RE: Pine Canyon Site Location and Trade Proposal Comments of the Town of Castle Rock

SITE APPLICATION ENGINEERING REPORT

Pine Canyon Water Reclamation Facility

AUGUST 26, 2020

Exhibit 1

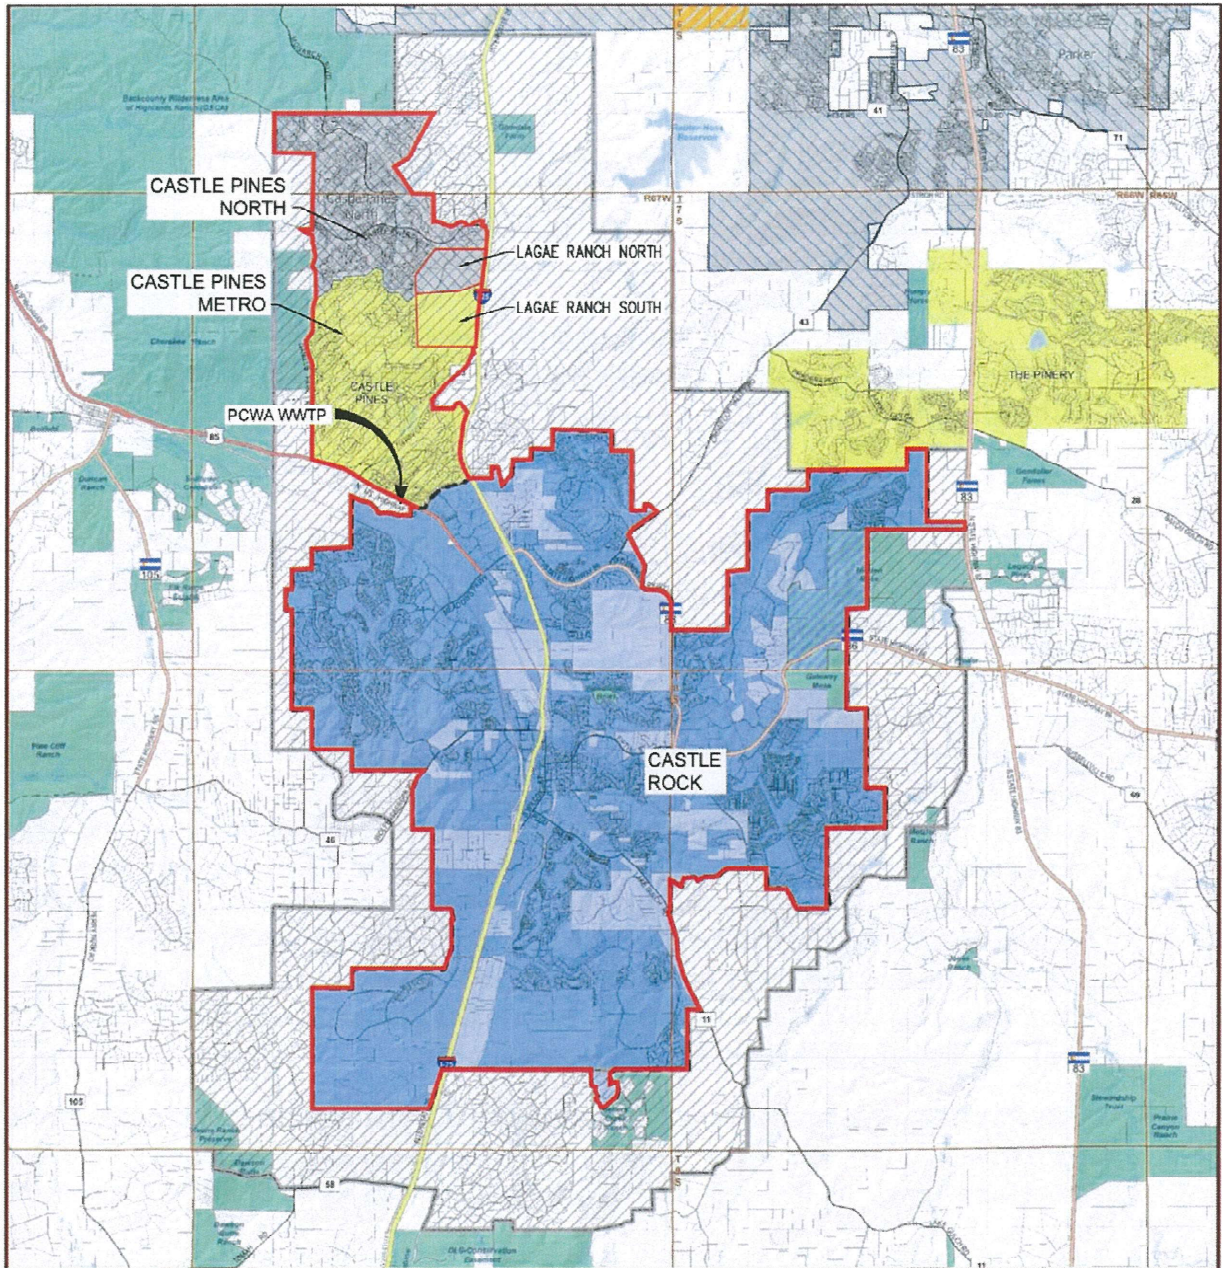
The proposed Pine Canyon development is located in the middle of Castle Rock. PCWRA has included the Pine Canyon area in its facility plan and will soon complete an expansion of its capacity that will allow it to treat growth in and around Castle Rock, including the area where the Pine Canyon development is proposed. The map attached as Exhibit 1 shows the current service area in the PCWRA utility plan.

Figure 1 Percentage of Annual Operation & Maintenance Costs for MBR

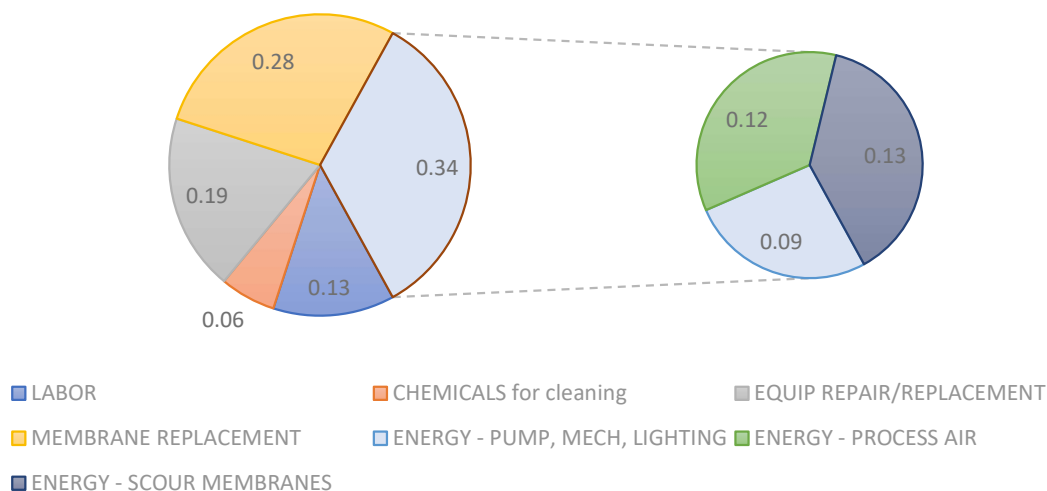
The following figure provides an estimate of the O&M costs by category³. Chemicals for membrane cleaning is estimated at 6%. The labor, estimated at 13% of the annual O&M cost, is for a full-time staff. Combined power costs were estimated to be 34% of the annual O&M budget. Power costs for running pumps, barscreens, HVAC, and lighting are estimated to be 9% of the annual budget. Blower power costs for process air are estimated to be 12% of the annual O&M budget. Blower power costs for membrane scour were estimated to be 13% of the annual O&M budget. Annual costs for membrane replacement are estimated to be 28% of the annual O&M budget. Repair and replacement maintenance costs are estimated to be 19% of the annual O&M costs. Chemicals for membrane cleaning is estimated to be 6%. Chemical addition for nutrient removal would increase the chemical fraction of the annual O&M costs.

Annual O&M costs for a MBR include costs for membrane replacement, and power costs for membrane air scour to prevent fouling. The annual O&M cost of \$780,000 for a SBR would have a corresponding annual O&M cost of \$1,322,034 for a MBR.

Figure 2 Castle Rock Community Surrounding Pine Canyon

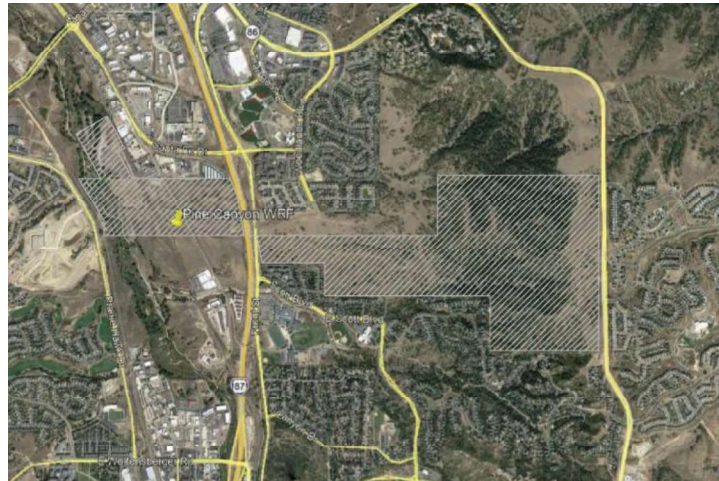
The Pine Canyon parcel is surrounded by the Castle Rock community.

The Pine Canyon service area will be sited on a 540-acre parcel, located in Sections 34-36, Township 7 S, Range 67 W, of the 6th Principal Meridian. The parcel has been broken off from the original 1,800-acre Scott Ranch, and is currently unincorporated Douglas County. The parcel is surrounded by the Castle Rock community. Figure 2 shows the approximate parcel as the screened area. The parcel is divided into two portions by Interstate 25 and surrounded by Castle Rock's residential communities. Pine Canyon's east portion is surrounded by the Woodlands Metzler Ranch community to the North, the Terrain community to the East of Founders Parkway, the Woodlands subdivision to the South, and I-25 to the West. The West portion is bordered by offices and industrial development to the North and South, I-25 to the East, and adjacent to a golf-course and Red Hawk community to the West.
